RFI 88  
DUCT WORK MODIFICATIONS

Drawing Title  
SECOND FLOOR MECHANICAL PLAN  
Approved: Project Director

Project Title  
POLYTRAUMA TRANSITIONAL HOUSING  
Location  
Audie L. Murphy Memorial Veterans Hospital  
San Antonio, Texas  
Date  
28 JULY 2010  
Checked  
Drawn

Project Number  
671-237  
Building Number  
1  
Drawing Number  
MH1.2  
Dwg. 3 of 10

1 SECOND FLOOR MECHANICAL PLAN  
SCALE: 1/8" = 1'-0"

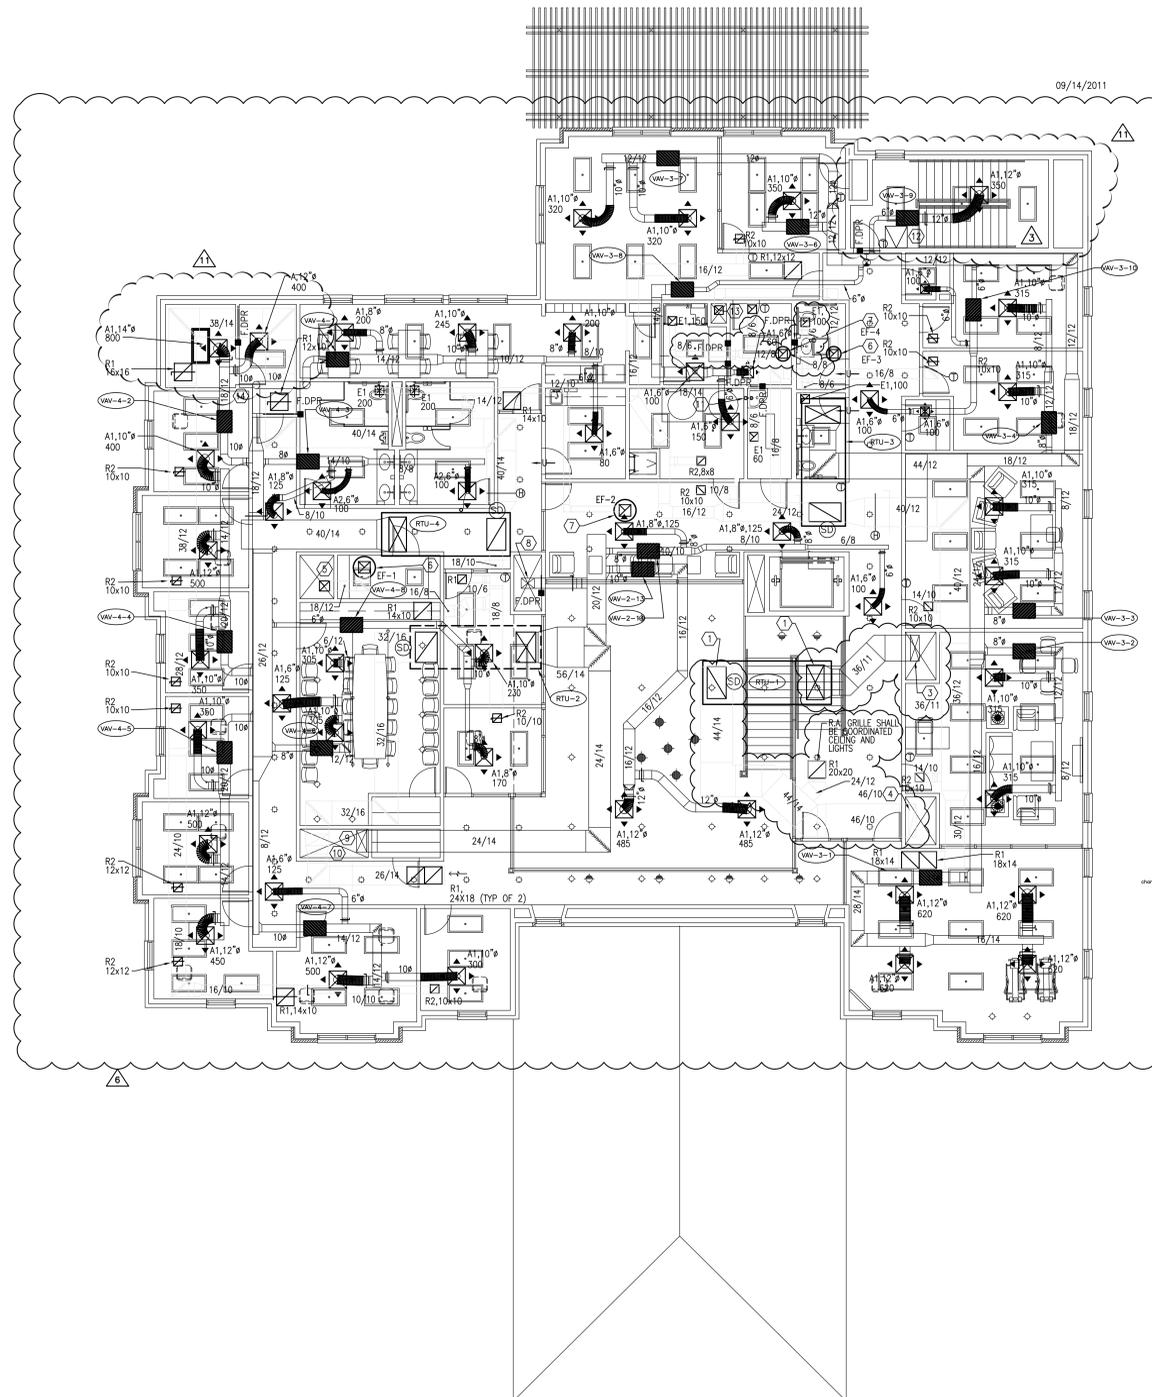
- 09/14/2011
- RELOCATE RTU-2 TOWARDS EAST ENOUGH TO CLEAR STRUCTURAL BEAM. ENSURE THAT SUPPLY FLENUM AND WRAP INSULATION CLEAR BEAM. MECHANICAL CONTRACTOR TO COORDINATE FIELD PRIOR TO ROUGH-IN.

- 09/14/2011
- 30 X 20 SUPPLY AND RETURN AIR DUCTS UP TO ROOFTOP CONNECTION. PROVIDE TRANSITIONS AND FLEXIBLE CONNECTIONS AT UNIT.
  - 22 X 34 SUPPLY AIR AND 32 X 34 RETURN AIR DUCTS UP TO ROOFTOP CONNECTION. PROVIDE TRANSITIONS AND FLEXIBLE CONNECTIONS AT UNIT.

- △ FIRE DAMPERS TO BE RELOCATED AT FLOOR PENETRATIONS
- △ HEAT TRACE NOT REQUIRED FOR CHILLED WATER PIPING. PIPE WILL BE INSULATED AND INSTALLED WITH METAL JACKET.
- △ X210 CEILING FIRE DAMPER LOCATE TO EXHAUST DUCT PENETRATING WALL BETWEEN ROOM X210 & X204.
